MWO 9-2320-273-20-1

M O D I F I C A T I O N W O R K O R D E R

TRUCK TRACTOR, LINE HAUL,
50,000 GVWR, 6 X 4, M915 (NSN 2320-01428-4395)

1. **PURPOSE.** This modification consists of procedures to add a new air tank to the compressed air system.

FIGURE 12

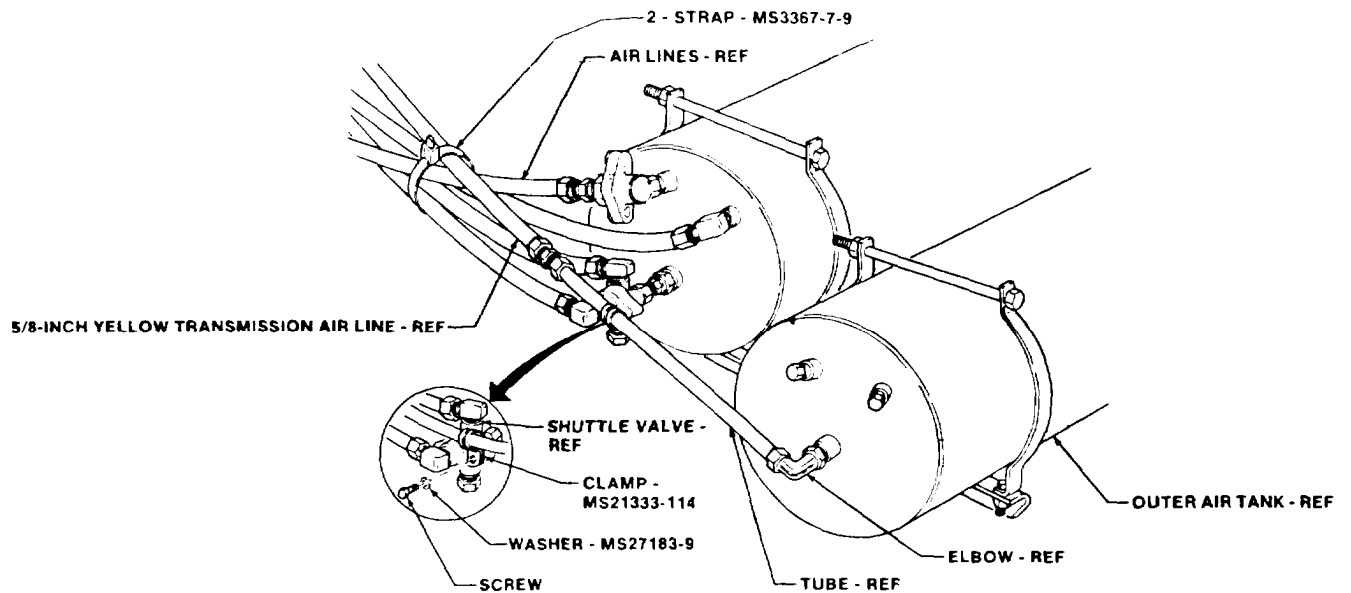
(18) Remove screw from shuttle valve and install MS21333-114 clamp around tube and secure tube to shuttle valve with screw and MS27183-9 washer as shown in figure 12.

(19) Secure 5/8-inch yellow transmission air line to air lines with MS3367-7-9 strap as shown in figure 12.

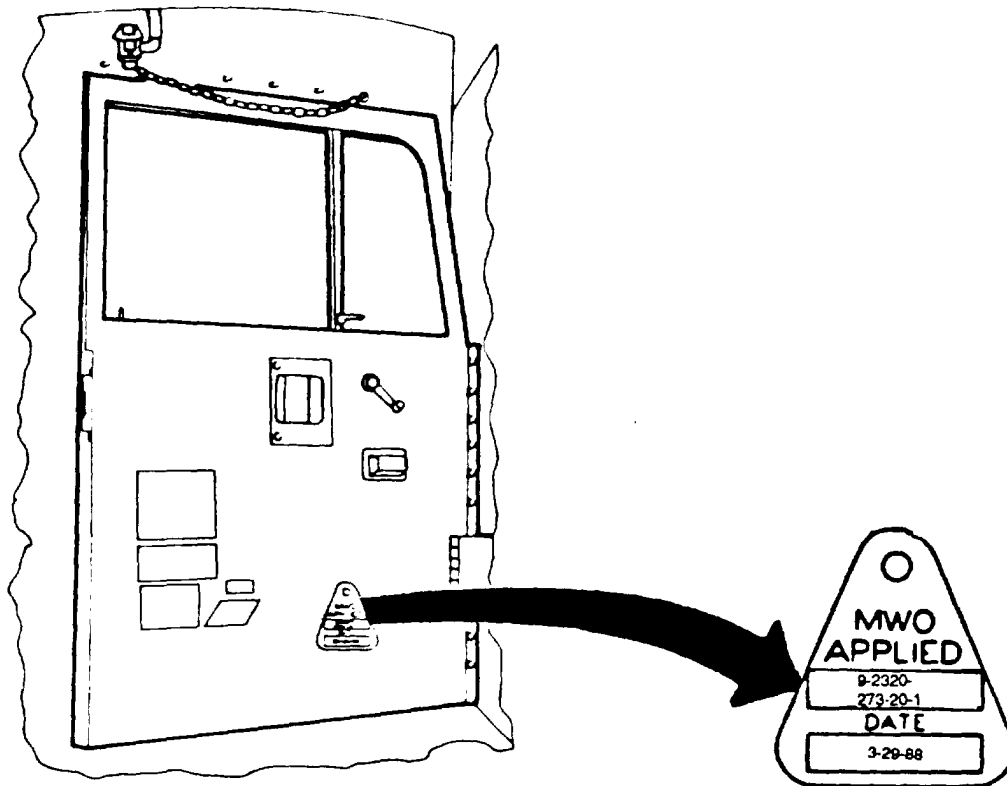
(2) Install MWO date plate by drilling one 3/64 inch (#37 drill) hole in cab door and secure with drivescrew NSN 5305-00-253-5614 as shown in illustration.
